AMENDMENTS OF THE DRAWINGS

The attached two (2) replacement sheets of amended drawings and two (2) annotated sheets include changes to FIGS. 1A, 1B, and 3. The replacement sheets (1/7) and (3/7) should replace sheets (1/7) and (3/7), as originally filed and as presented in the formal drawings filed June 30, 2004. In the amended drawings filed herewith, the following amendments have been made which are also indicated on the annotated drawings also filed herewith:

REMARKS

FIG. 1A
(PRIOR ART)

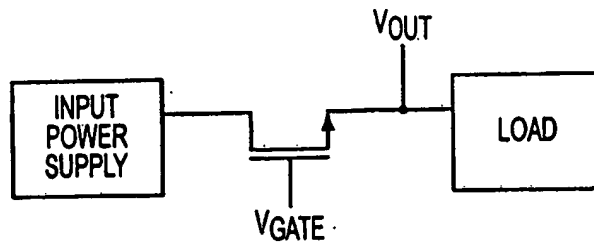
(1) FIGS. 1A and 1B have been labeled as "PRIOR ART" as suggested by the Examiner in the pending Office action; and

FIGS. 1A-1B and 2A-2D were objected to for not being designated as "Prior Art."

The Examiner objected to FIGS. 1A-1B and 2A-2D for not being designated as "Prior Art."

Applicant has amended FIGS. 1A and 1B to provide "Prior Art" designations. Accordingly, applicant respectfully requests that the objection to FIGS. 1A-1B be withdrawn.

FIG. 3

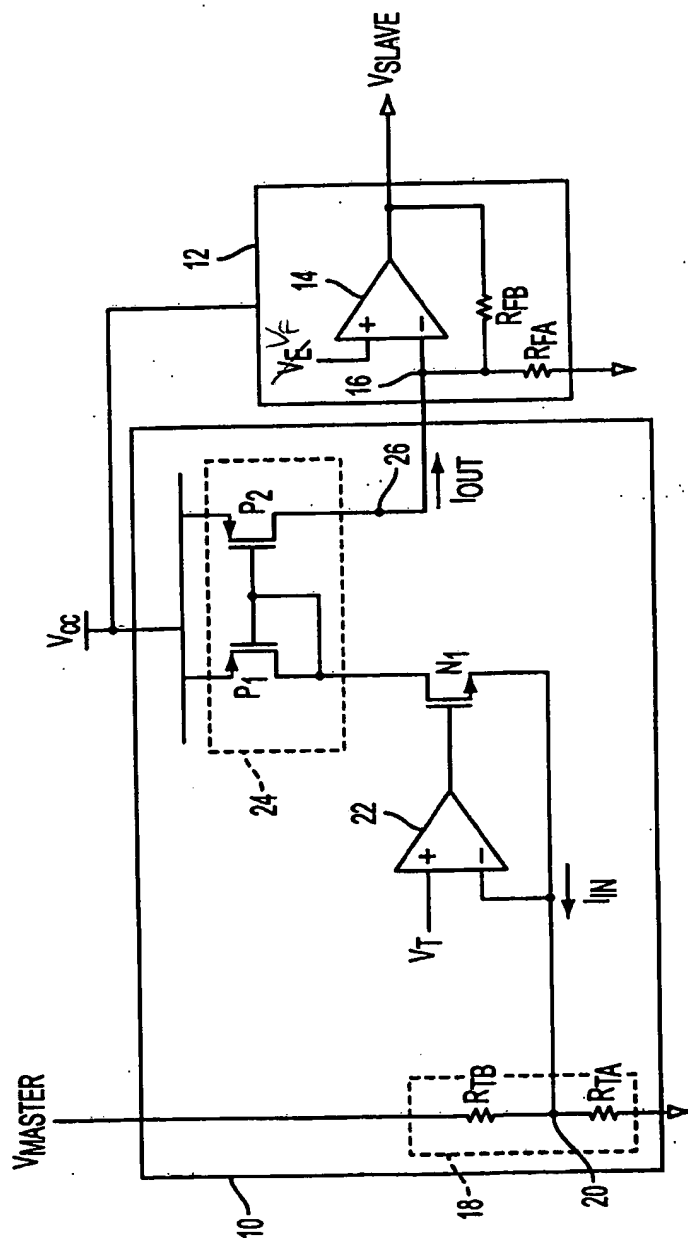
(2) the signal transmitted to the non-inverting input of amplifier 14 in FIG. 3 has been changed from " V_E " to " V_F " in accordance with the specification at page 6, lines 16-20.

The Examiner objected to the specification and to FIG. 3 for containing various informalities.

Applicant also has amended FIG. 3 so that the signal transmitted to the non-inverting input of amplifier 14 now recites " V_F " (rather than " V_E ") in accordance with the specification at page 6, lines 16-20.
